LAWSON EARTH MATERIALS EXCAVATION

EAST HAMPTON, CONNECTICUT

**Eastern Connecticut
Environmental Review Team
Report**

August 2000

Figure 4.
Site Plan Continued
Not to Scale

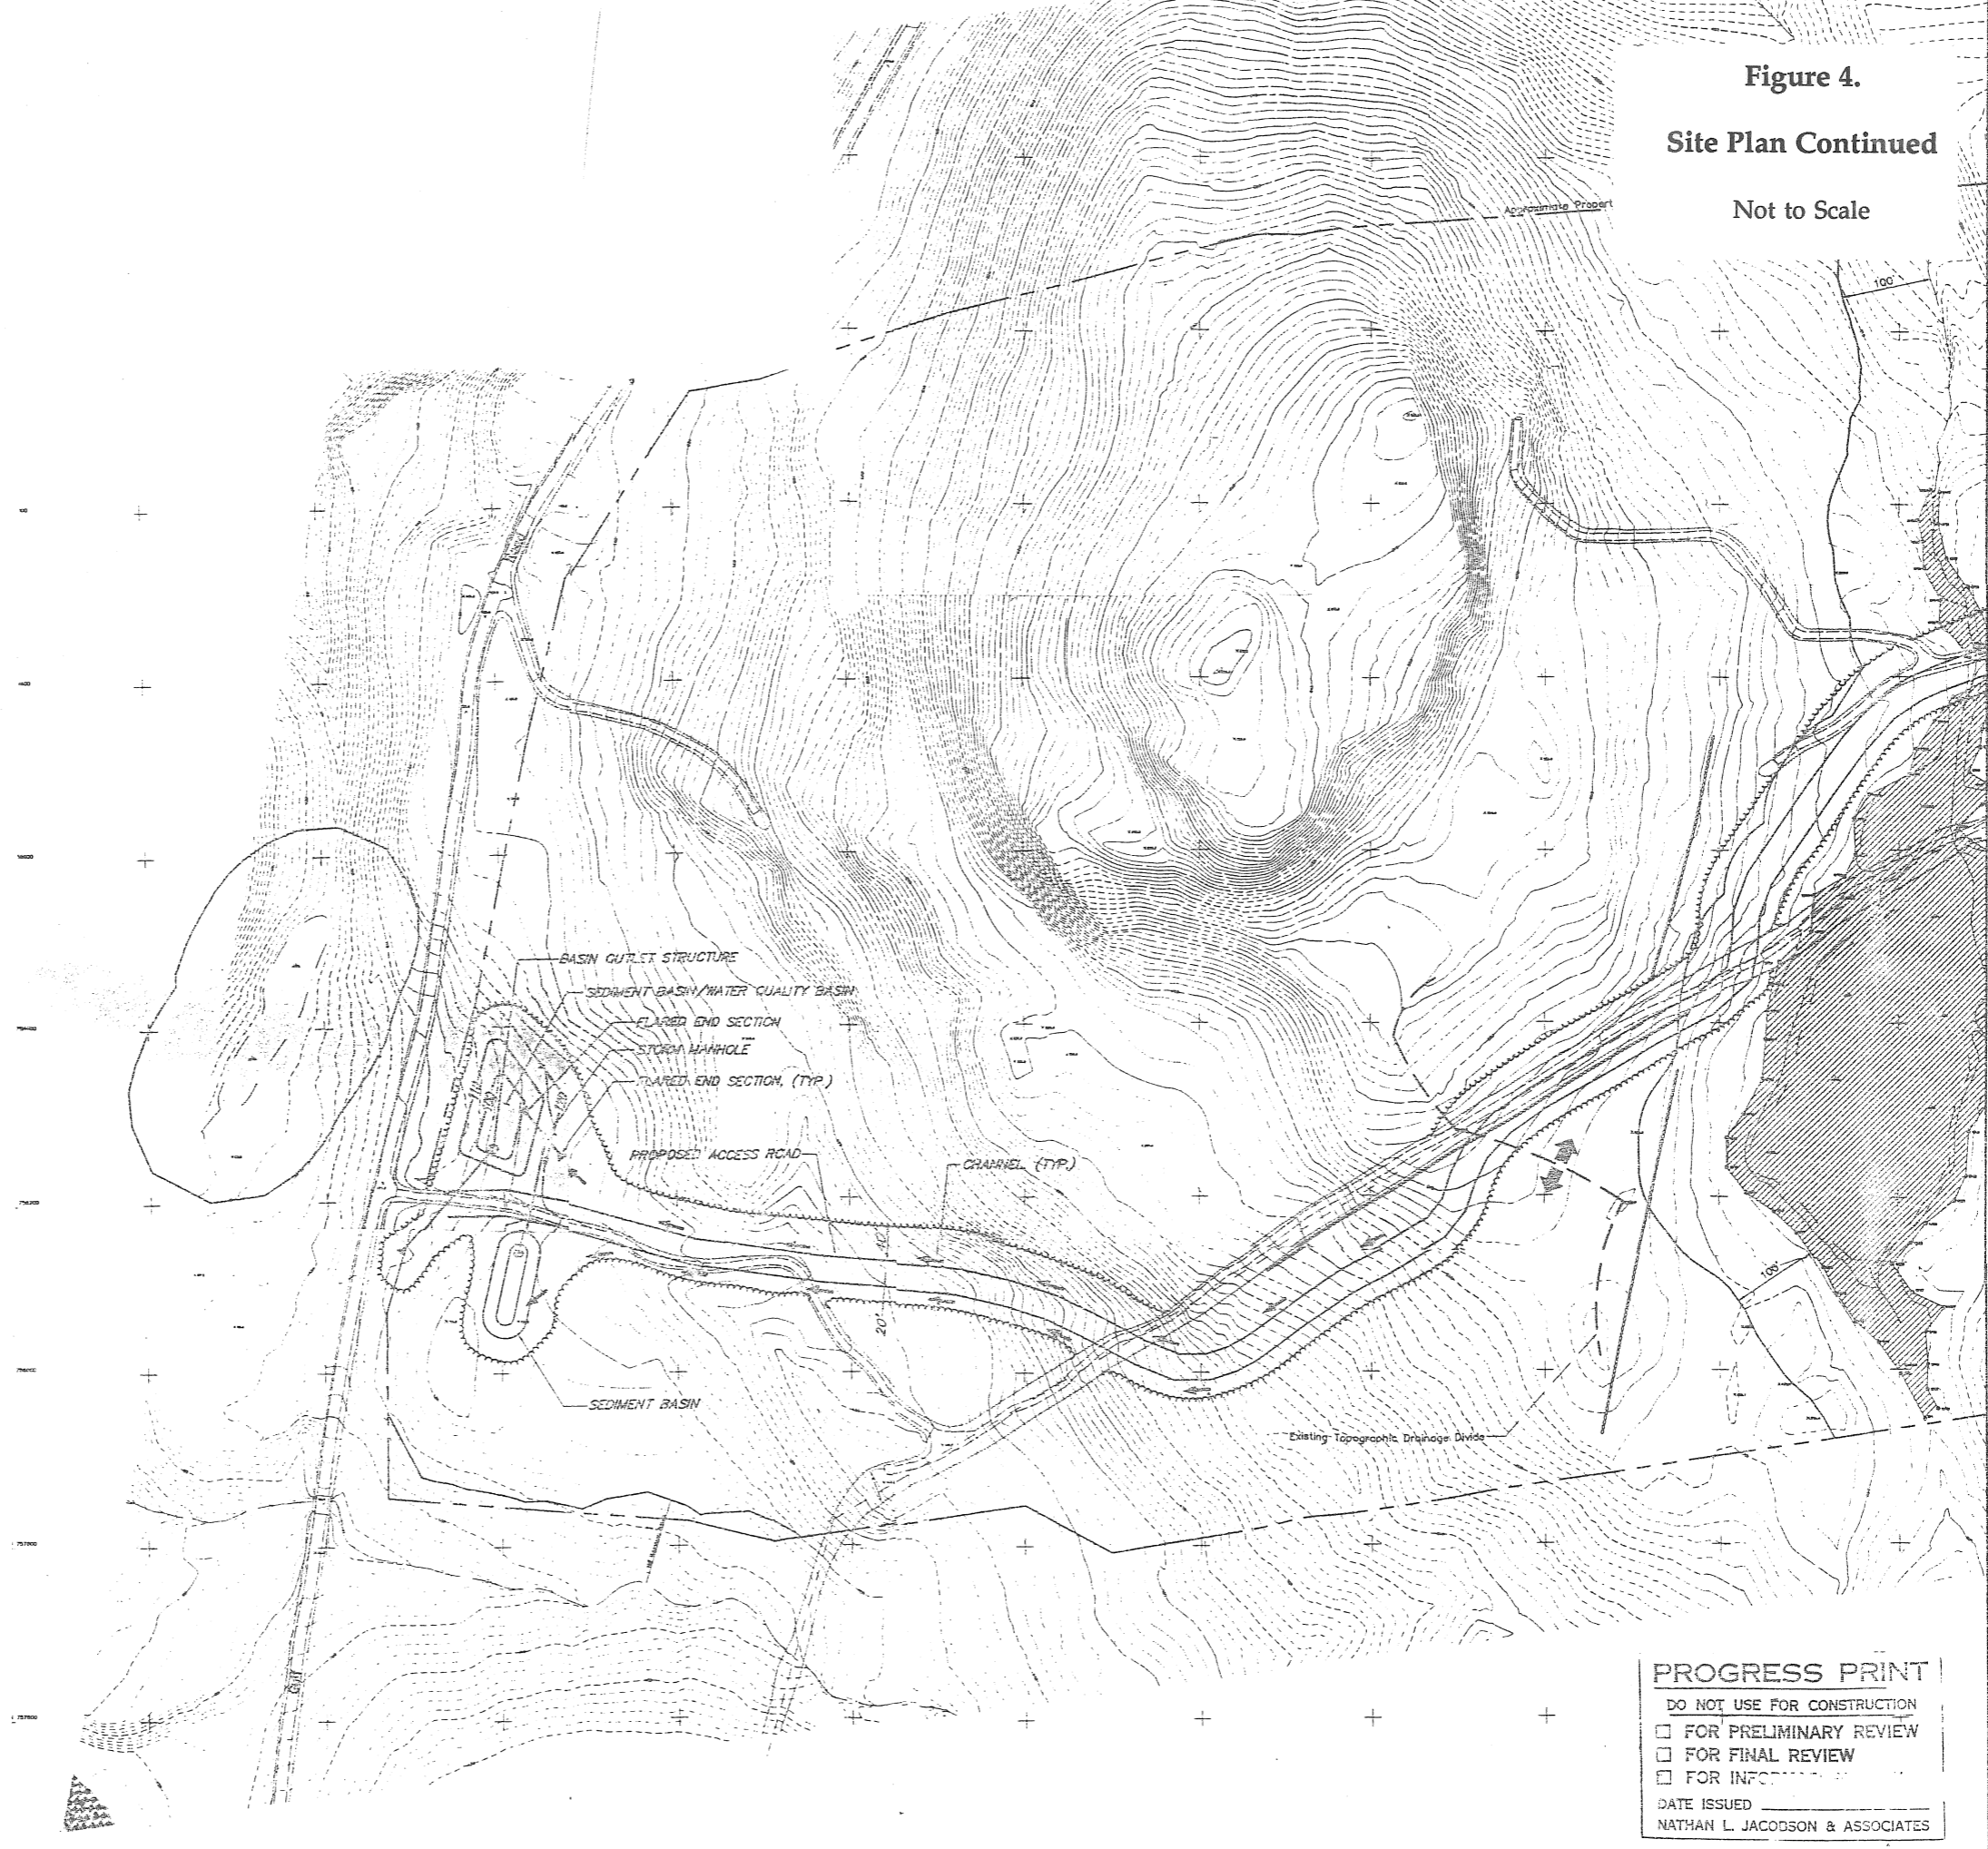
- The westerly sediment basins on Sheet 2 have no outlet shown. The plan should be revised to include the outlet structure and a detail must be included of the structure. If the banks of the basins are to serve as level spreaders, this should be shown on the plans. Consideration to protection of nearby wetland areas should be given in design of the outlet structure.

- The reverse slope benches should be sloped at 1-2% to convey diverted water to a stable outlet.
- A detail must be provided for the filter berm in the easterly sediment basin on Sheet 2.

- The location of all controls shown on the site details sheet (infiltration trench, riprap channel, grass channel, check dams, etc.) should be identified on the site plan.

Figure 5.

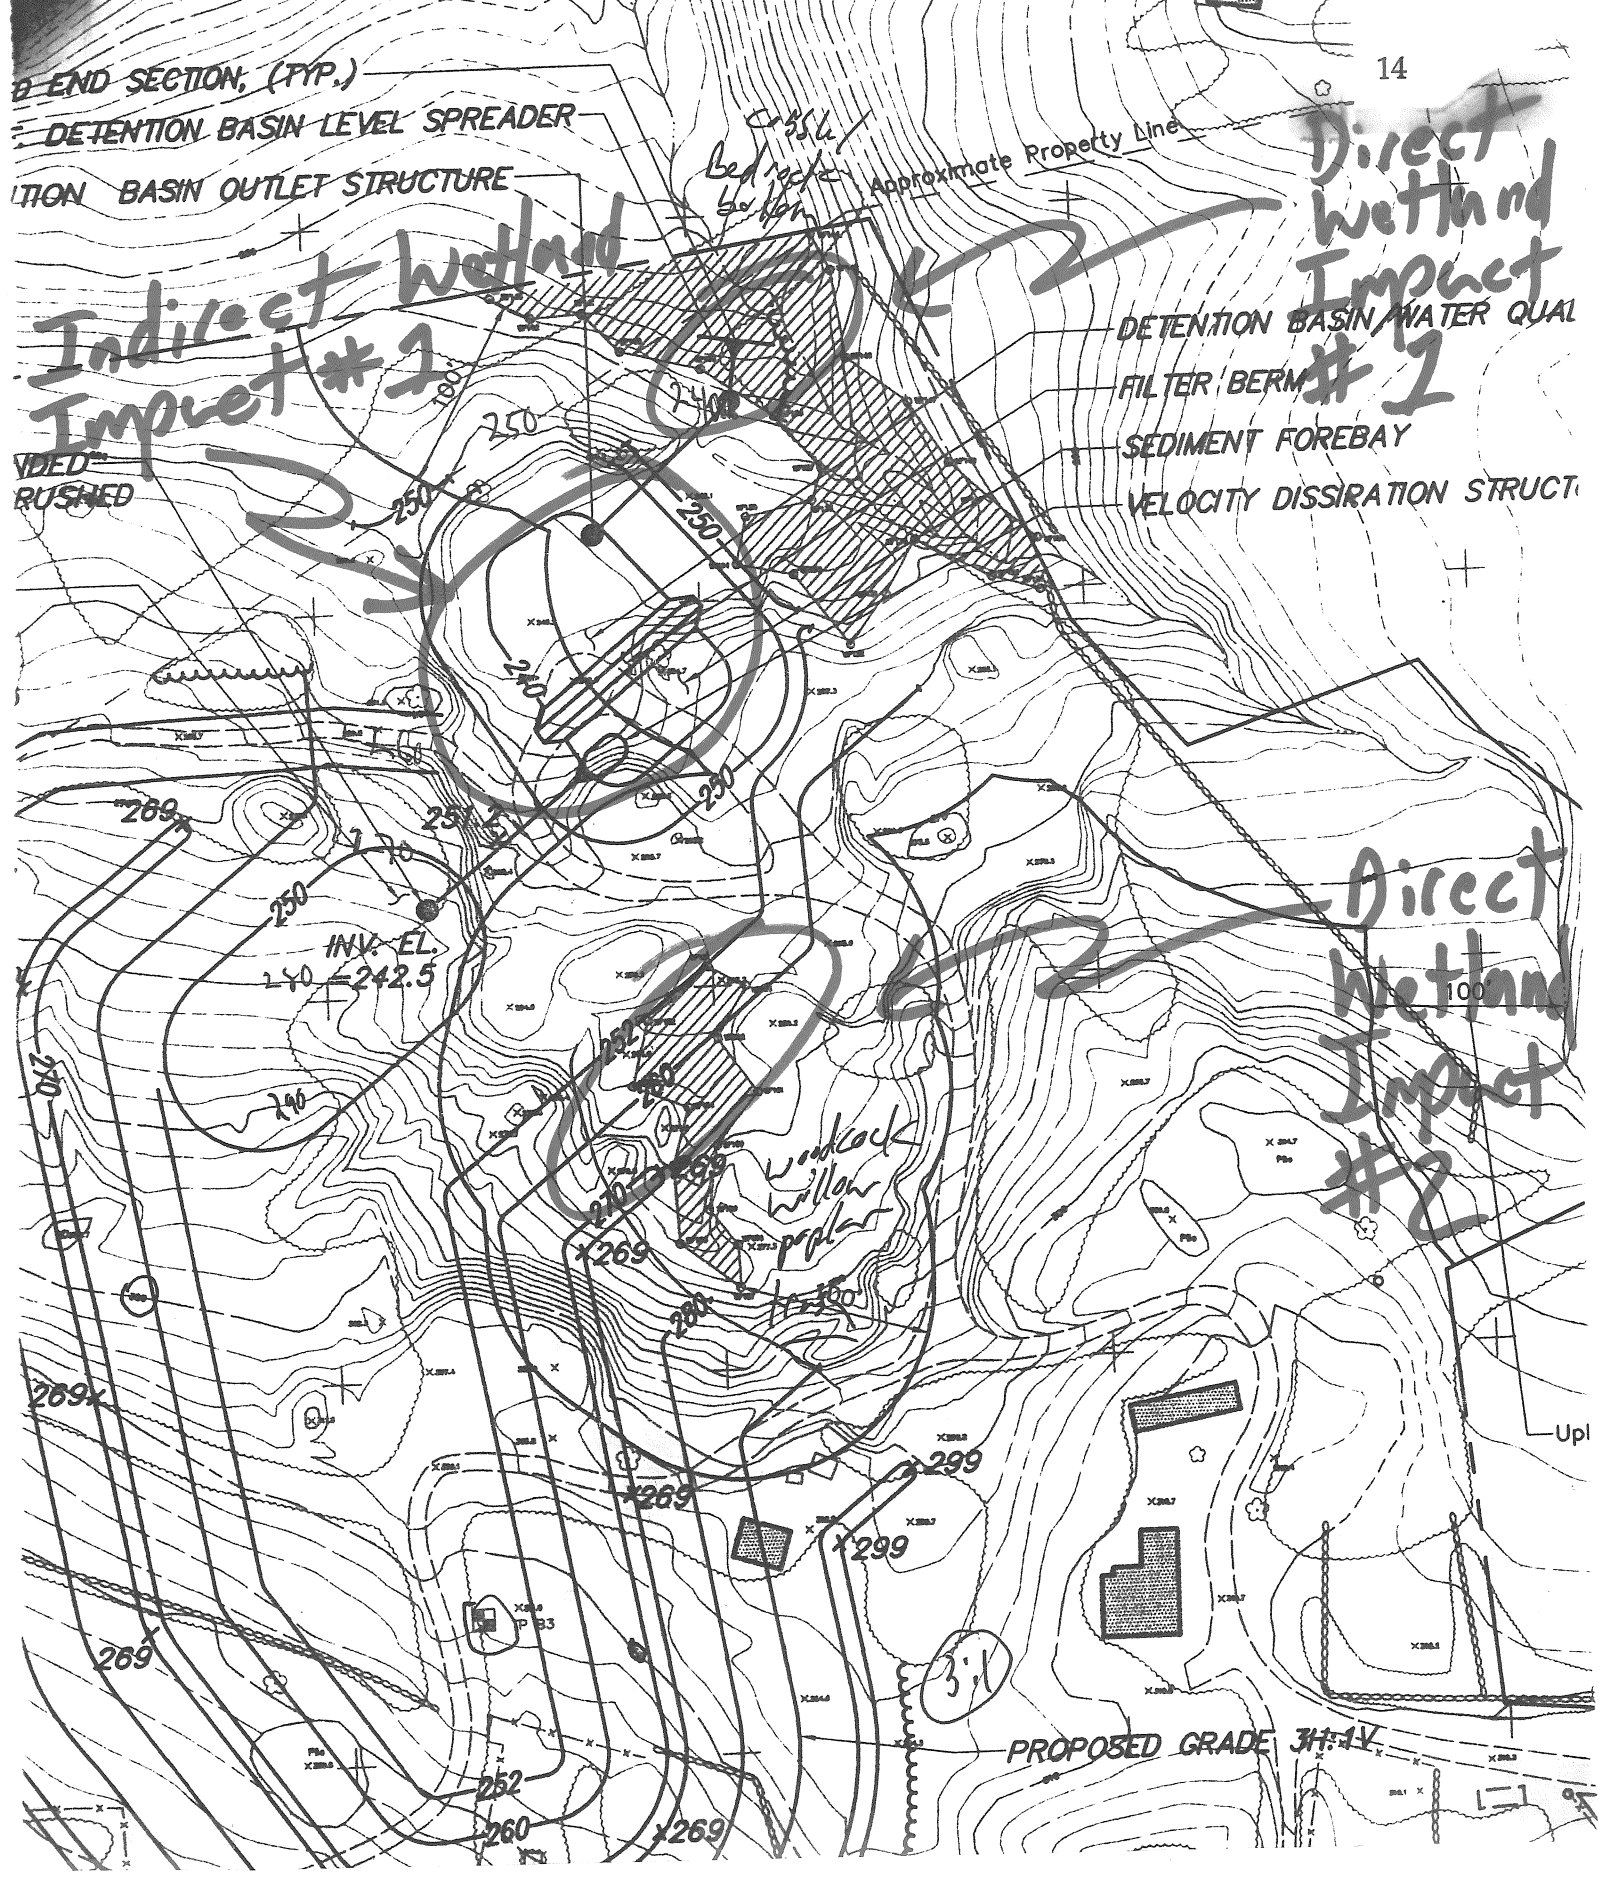
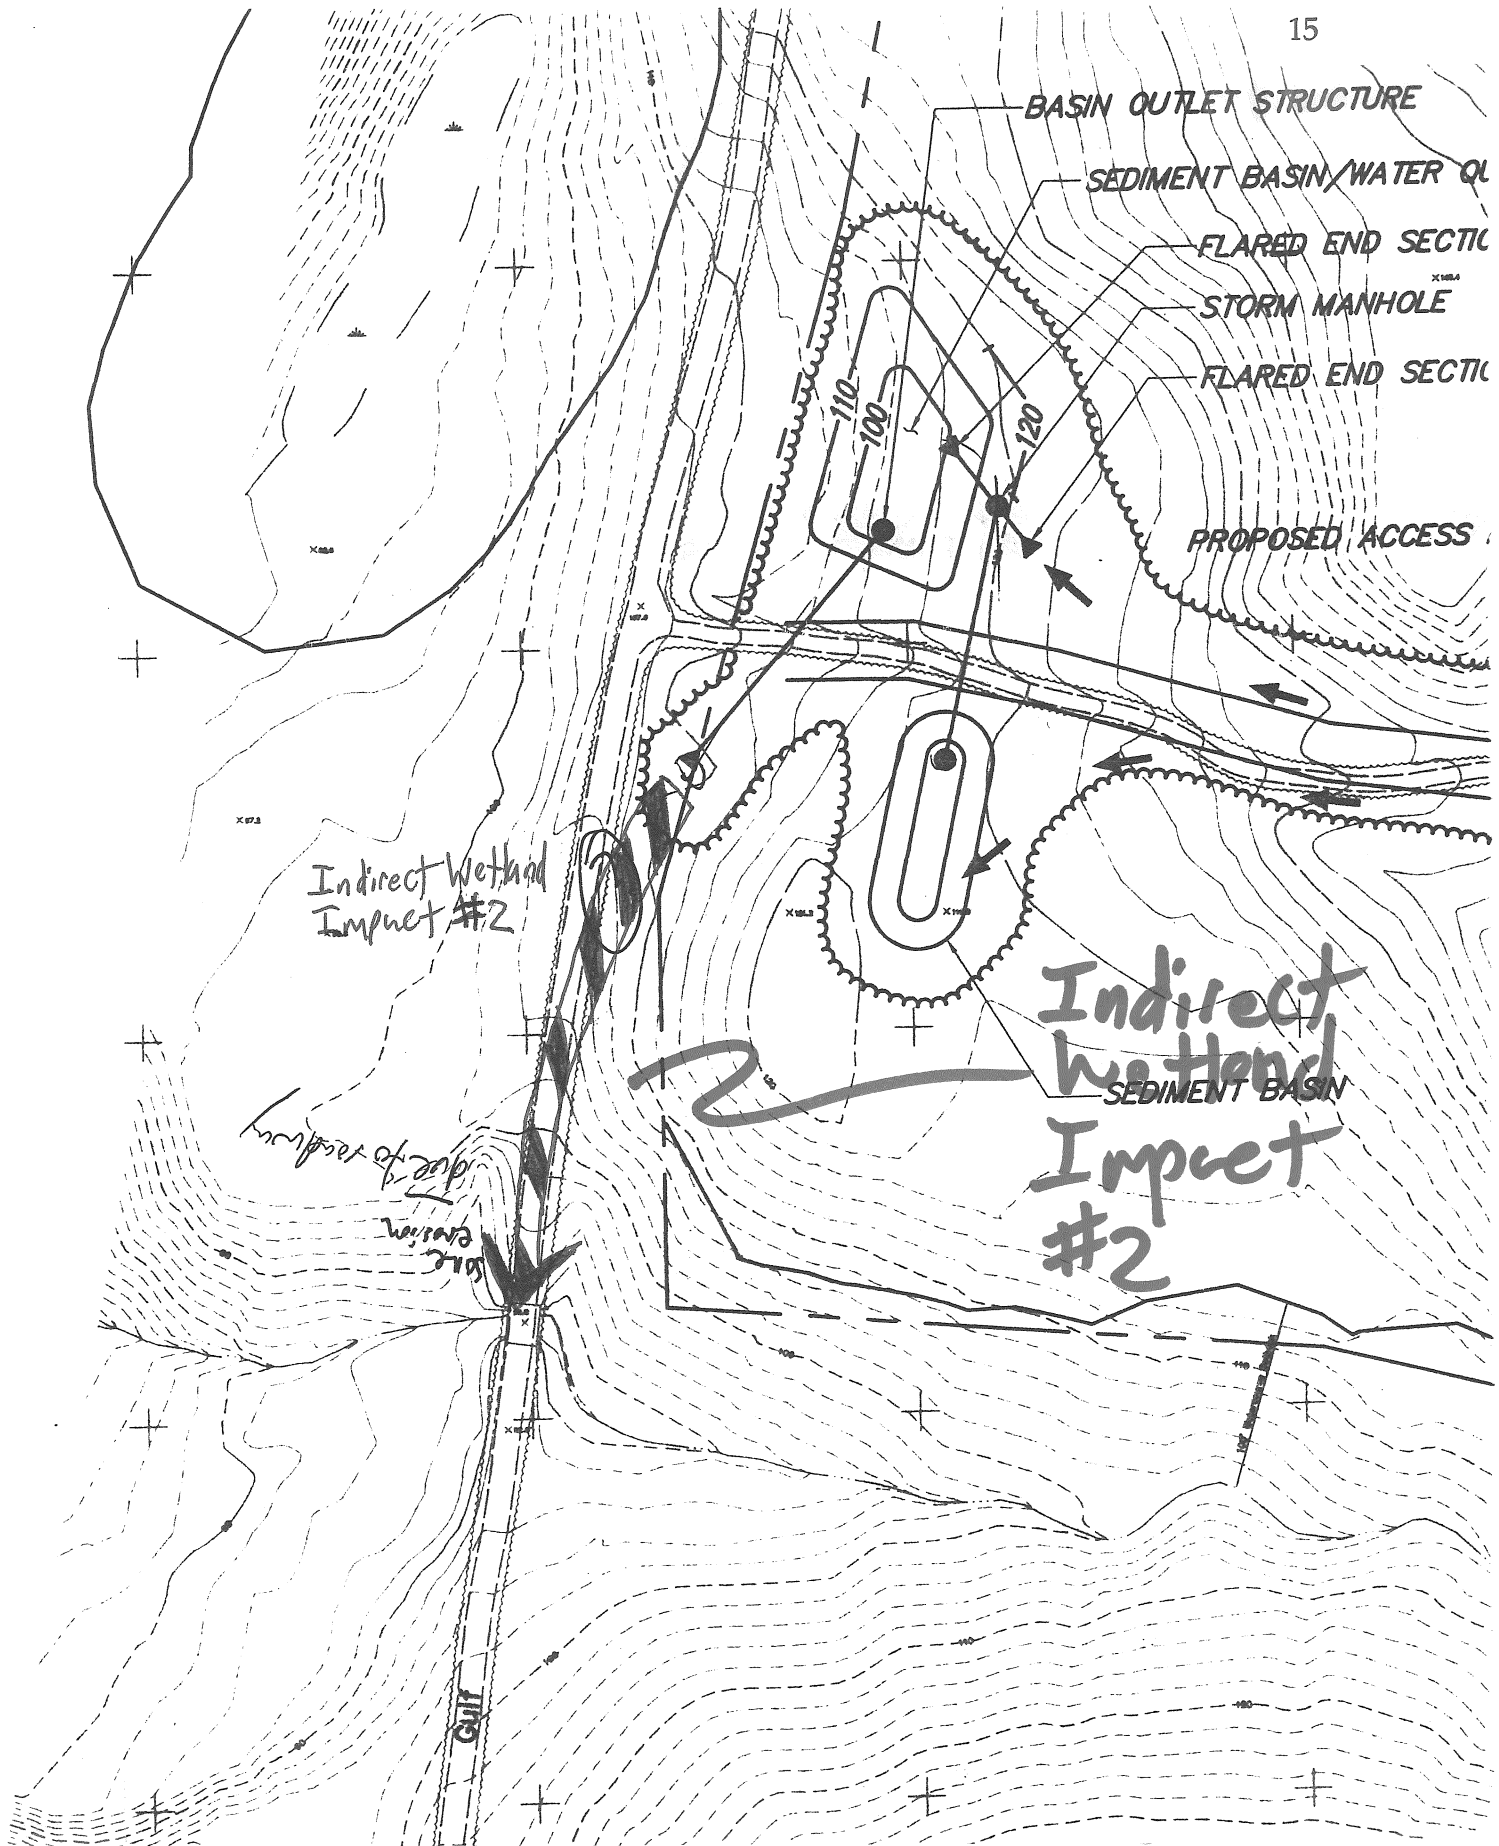
- 1) where a stormwater outlet is proposed within the riparian wetlands associated with unnamed watercourse that cuts across the northeastern portion of the parcel, and
- 2) on the eastern edge of the gravel extraction area where grading is indicated for a portion of a relatively small pocket of wetlands located to the south of the riparian wetlands referred to above (see attached maps for locations, Figures 5& 6).

However, the second direct impact does seem to be avoidable. This small, isolated wetland consists of a thin cover of young trees, primarily willow and poplar, with scrub/shrub growth on the surface. The wetland probably rarely contains standing water and seems to have been created as a result of the historic gravel removal close to groundwater levels. As small as the wetland is, it does have some value as a refuge for wildlife, particularly birds and small mammals, in the midst of the severely altered landscape of the historic gravel pit. As the Team wetland specialist was inspecting this area, he observed a woodcock burst from the grasses as it fled from his approach. Since this proposed impact is

located on the edge of the working area, it would not be that difficult to remove this area, as well as an adequate, undisturbed buffer, from the proposed operation.

- 1) grading within the wetland/watercourse buffer in proximity to the riparian wetlands associated with unnamed watercourse that cuts across the northeastern portion of the parcel as a result of the construction of a detention basin, and
- 2) potential sedimentation of an unnamed, off-site watercourse as it crosses Gulf Road as a result of erosion along the haul road in the western portion of the parcel (refer to Figures 5 & 6).

The first indirect impact will occur as a result of the construction of a stormwater detention basin designed to store water collected from the proposed gravel extraction area. It is not clear why this structure is being proposed unless, as some towns do, it is required of all development proposals that predict any increase of peak-flow discharges off the site. Even with that requirement in place, the increase, if any, would most likely be negligible, given that there will be no impervious surfaces created as part of this project. It is recommended that the need for this structure be re-evaluated and avoided if possible in order to preserve this valuable wetland buffer area.

The ERT discussed several options that would decrease the chances for the second indirect impact to occur. The concentrated out-fall of stormwater proposed next to the unimproved Gulf Road raises concerns for subsequent erosion of this road and the potential for sedimentation of the unnamed watercourse located approximately 300 feet down-slope. Any efforts to break up the contributing watershed (primarily consisting of approximately 1400 linear feet of unpaved access road) leading into this outfall would decrease this

potentiality. Leak-offs along the access road at appropriate locations with stable outlets are recommended. In addition, a roadside gutter or piped stormwater line with drop manholes (along Gulf Road) should be investigated if substantial stormwater volumes are predicted from the proposed outfall.

Indirect Wetland Impact #1

Direct Wetland Impact #1

Direct Wetland Impact #2
